APPENDIX E

PROJECT QUALITY ASSURANCE QUALITY CONTROL PLAN

SECTION 11: PROCEDURE FOR VERIFICATION OF ATTAINMENT OF THE OPTION 2 CRITERION FOR STABILIZED SLUDGE RADIOACTIVITY LEVELS

**REVISED 5/23/97
AND
MODIFIED TO SHOW ALL TEXT OF
ORIGINAL 10/17/95 VERSION**

Figure 11-2 Cumulative distribution of sludge stabilization simulation results.

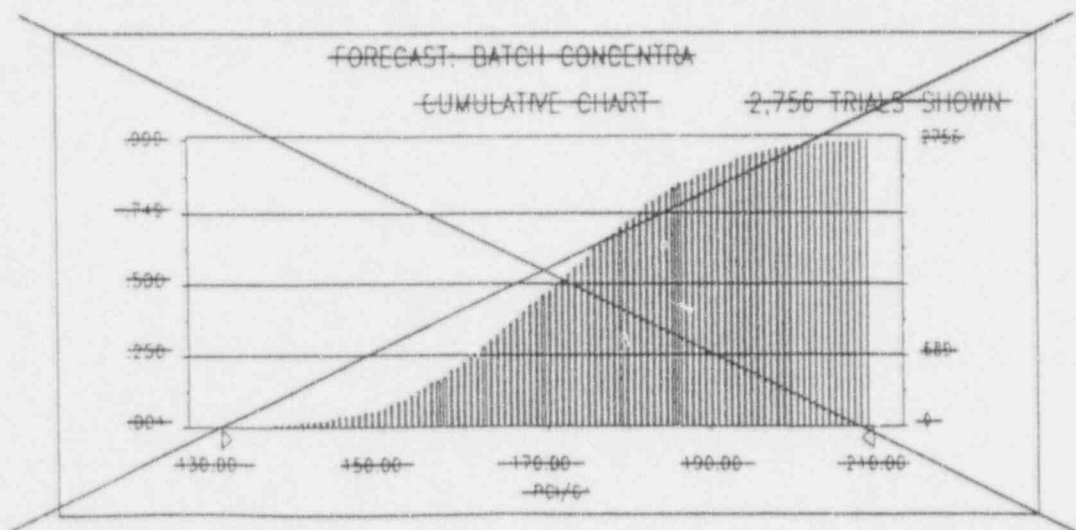
~~Samples were taken of the unstabilized sludge in each of the ponds and analyzed for depleted uranium activity. The results of these analyses were presented in the report entitled, "Summary of Radioactivity of Sludges, Mixed Waste Pond Closure Project, BP Chemicals, Inc., Lima, Ohio." The data were statistically analyzed using the procedures presented in NUREG/CR 5840, Section 8.5. Using the 1994 data, the mean, the standard deviation and the upper 95% confidence limit were calculated. The results of these analyses are summarized on Table 11-1 below:~~

As can be seen from these analyses, the upper 95% confidence limit for the unstabilized sludges from the V-1, Deepwell and Celite ponds is less than 300 pCi/g. Sampling and analysis will be performed on the sludges from all of the ponds after stabilization. However, since it is the only pond from which raw sludge in excess of the 300 pCi/g criterion is anticipated, only the Burn Pond sludge is evaluated further in this section.

To evaluate the technical feasibility of the proposed sampling and analysis approach, a numerical simulation of the sludge processing operation was performed. The calculations for this evaluation are presented in Appendix 11-A. In this evaluation, the sludge was assumed to be added to a 20,000 gallon (80 cubic yard) conditioning tank. Total homogenization was assumed. The activity in each batch was generated randomly from the normal distribution defined by the statistics presented in Table 11-1. The results of the analysis are presented as a cumulative distribution on Figure 11-2. As can be seen from these figures, none of the solidified batches are expected to exceed the 300 pCi/g maximum criterion.
